**LEGAL ADVERTISEMENT
HISTORIC PRESERVATION BOARD
CITY OF PORTLAND
Public comments are taken at all meetings.**

On **Wednesday, July 20, 2016** at **5:00** p.m., the Portland Historic Preservation Board will meet in Room 209 of City Hall to review the following items. (Public comments are taken at all meetings):

Following two preliminary workshop sessions, the most recent of which was held on July 6th, applicants Constance Bloomfield and William McFarlane are returning for final review and approval of their plans for a new 2-family residential structure at 380 Danforth Street. Given the Board's recent review of the project and general support for the proposal as presented at the July 6 workshop, the following staff report is brief. This report highlights the changes made since the last workshop in response to Board comments.

ANTENNA FRAME ISOMETRIC

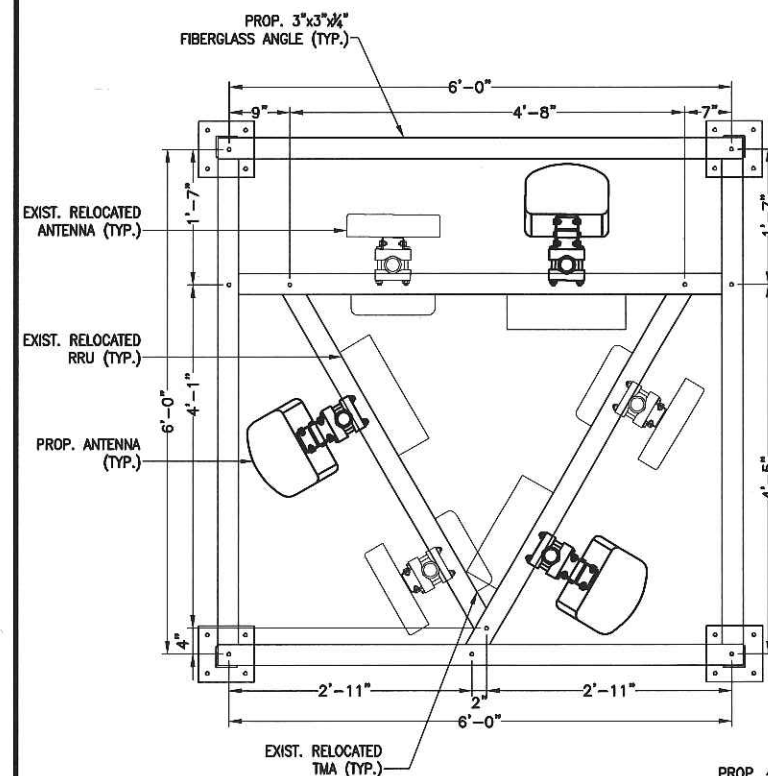
Crown Castle is proposing to replace an existing antenna assembly at the Congress Street end of the penthouse roof with additional antennae which are to be surrounded by a faux "chimney" made of fiberglass and painted to match the brick tones in other chimneys and the existing elevator overrun at the other end of the penthouse. The proposed faux chimney is 6'-5" square, and 10' high (apparently measured from the roof deck.) Staff assumes the antennae within the enclosure are nearly that tall. The material is to be fiberglass; according to the engineer the panels are typically a molded replica of brick construction, either smooth or textured, and painted to imitate brick. Plans show flat fiberglass trim around the top of the enclosure, but it does not appear there is an overhanging cornice. This detail might be adjusted according input from the Board.

- Color choice: If Board members judge a faux chimney to be a false addition of an architectural feature that calls attention to itself another option would be a smooth-walled enclosure painted the color of the penthouse. At the other end of the roof, near the elevator tower, a smaller, round stack was installed in recent years to conceal newly installed antennae.
- General screening of the penthouse roof: Would it be beneficial to add a visual barrier around the entire penthouse roof? This would increase the apparent vertical dimension of the penthouse, and might be an awkward and inappropriate addition.

SOUTH ELEVATION

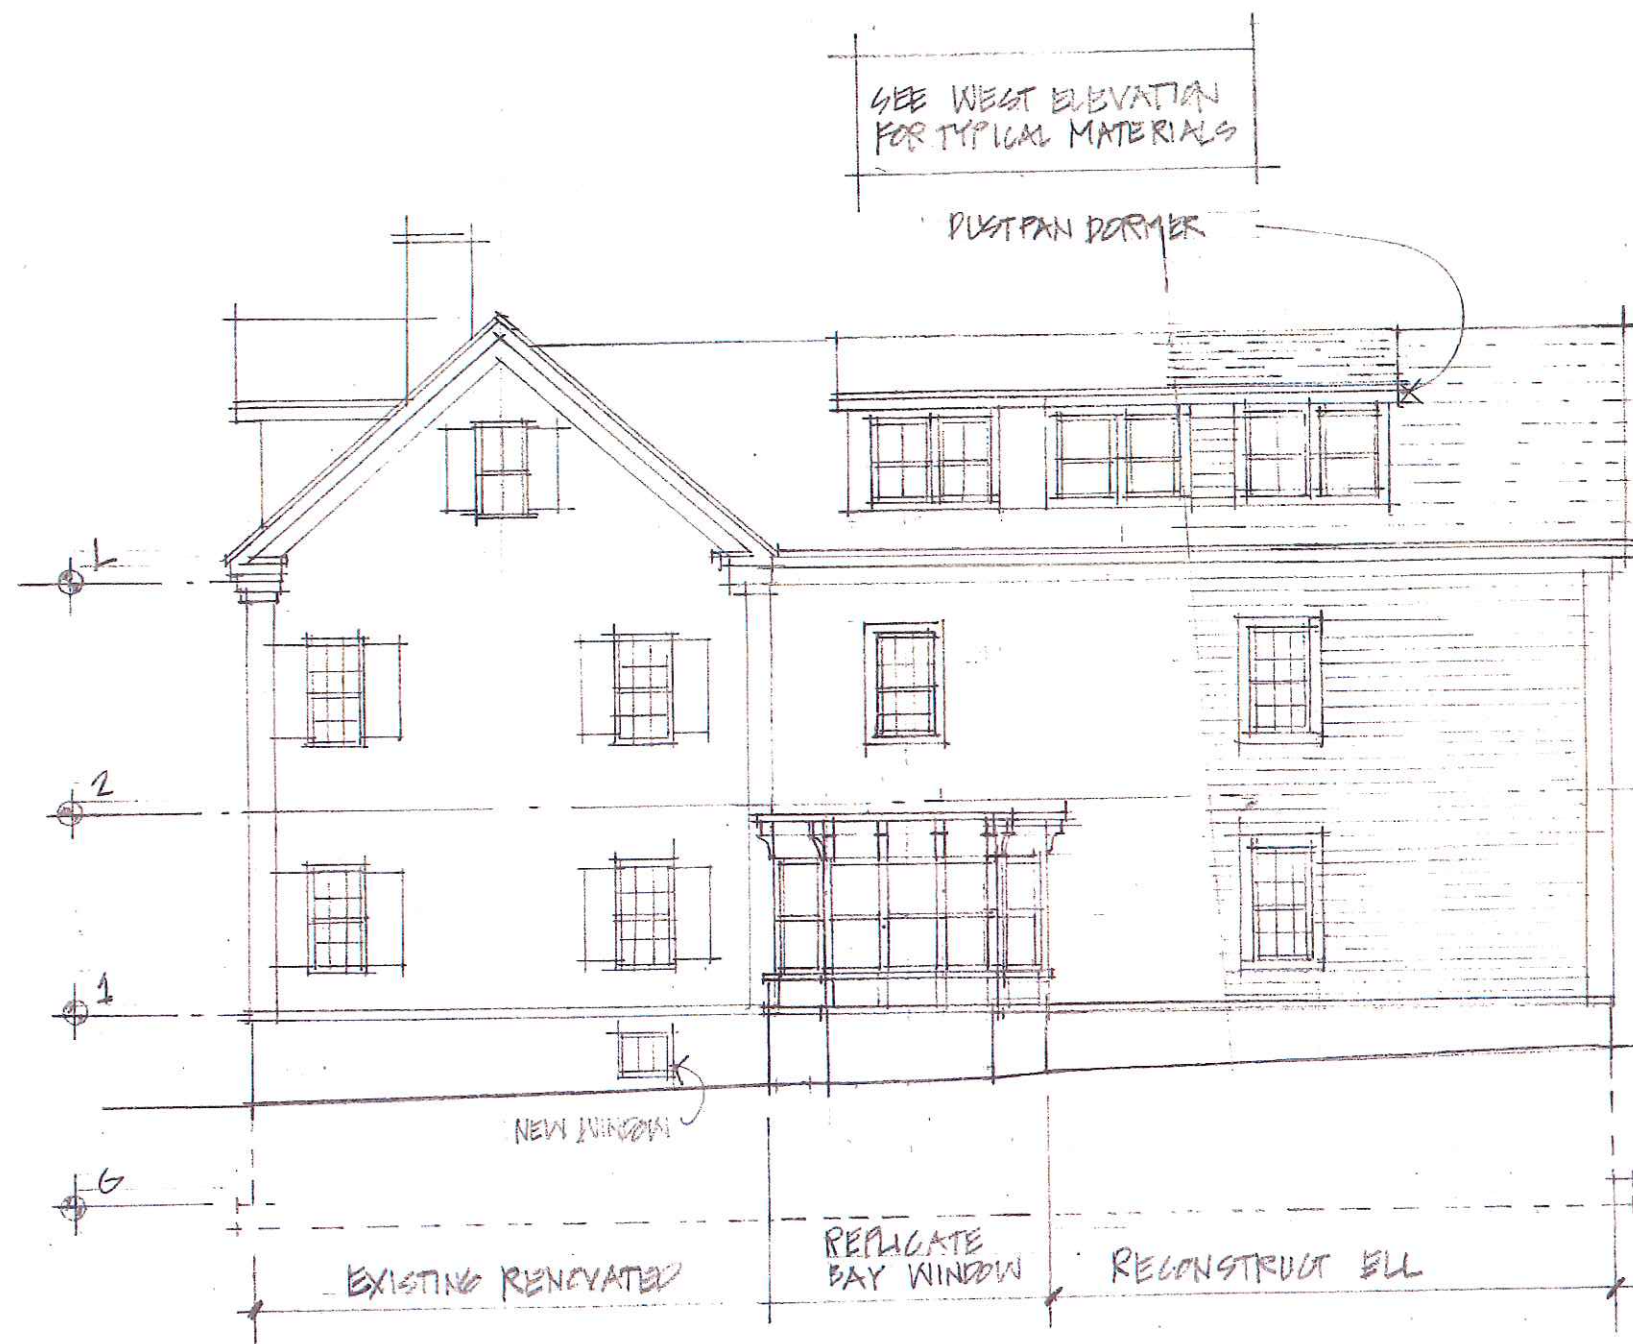
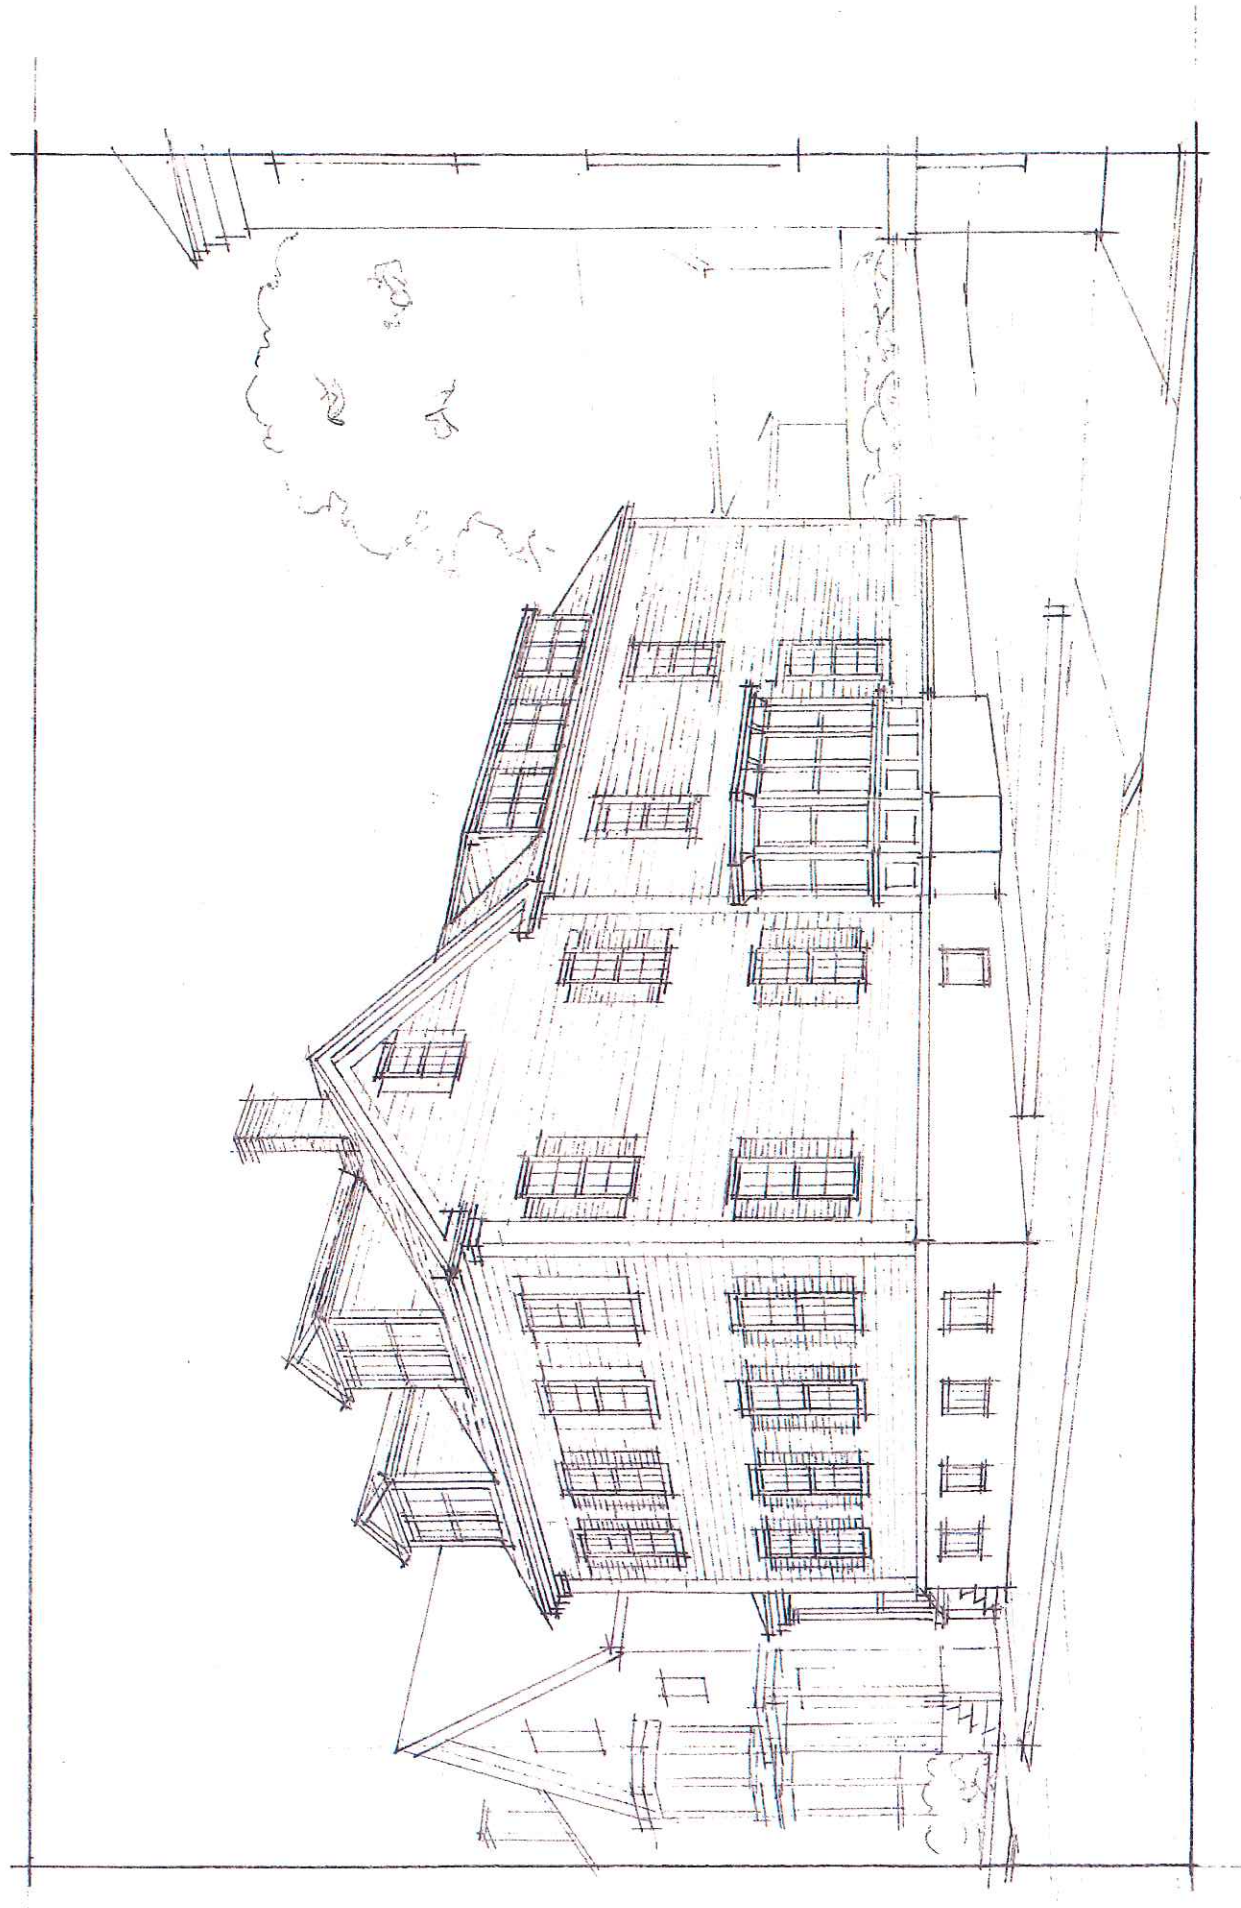
Mr. Harmon has prepared new drawings in response to Board feedback at the June 15 meeting, which focused mainly on the design of the rear ell. A number of Board members' concerns have been addressed in the revised plans. The proposal still includes the recreation of the west entry porch, where a smaller porch survives today with a modern concrete base. Mr. Harmon has provided new plans and elevations to illustrate the revised concepts for the ell, but few details of the new porch except the evidence visible on the 1924 tax photo.
